## ORGANIZACION HIDROGRAFICA INTERNACIONAL

CIRCULAR No. 55/2012  
23 de Mayo del 2012

### ADOPCION DE LA EDICION 2.0.0 DE LA PUBLICACION S-64 DE LA OHI "Colecciones de Datos de Pruebas para ECDIS de la OHI"

**COMMENTS BY MEMBER STATES  
IN RESPONSE TO CL 09/2012**

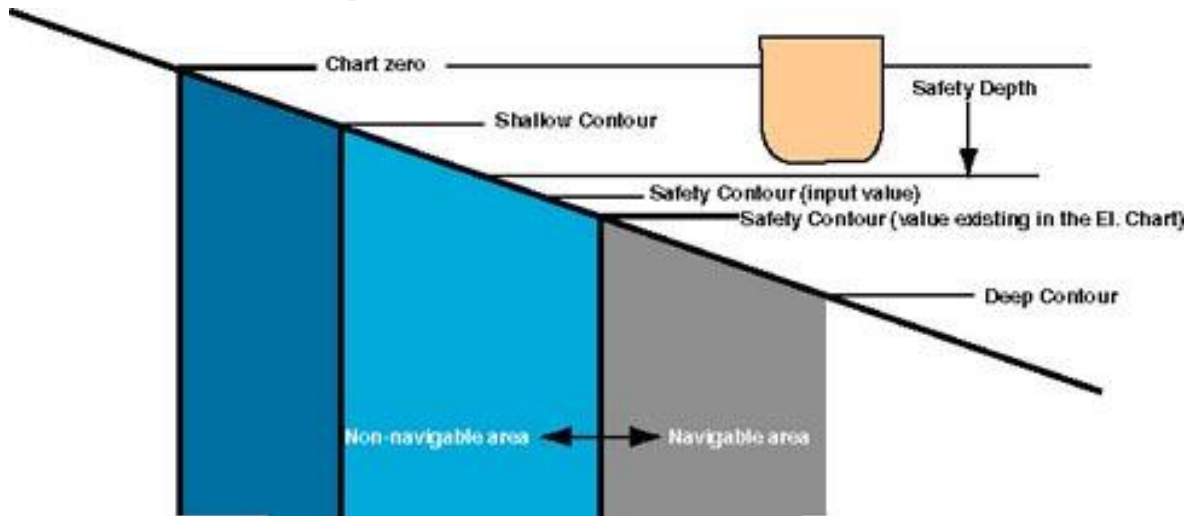
**Germany:** The attributes for the additional S-64 ECDIS test data sets on isolated underwater dangers do not comply with the usual coding of these objects. For isolated underwater objects the proposed S-64 ECDIS test data only provide the attributes WATLEV (Water effect level) and the respective category (CATWRK, CATOBS). This does not comply with the usual coding of these items. The following is a proposed addition of further usual attribution:

- Technique of sounding measurement- TECSOU
- Quality of sounding measurement - QUASOU
- Exposition of Sounding - EXPSOU
- Nature of construction - NATCON

(Note from IHB: BSH provided an ENC cell - GB400797.000 – reflecting the above additional attribution.)

**Comment by IHB:** All suggested amendments that are editorial in nature have been included in the final text. The remaining comments and the ENC cell were passed to TSMAD for further correction to S-64 e2.0.0, as appropriate. The following particular comments have been made by TSMAD:
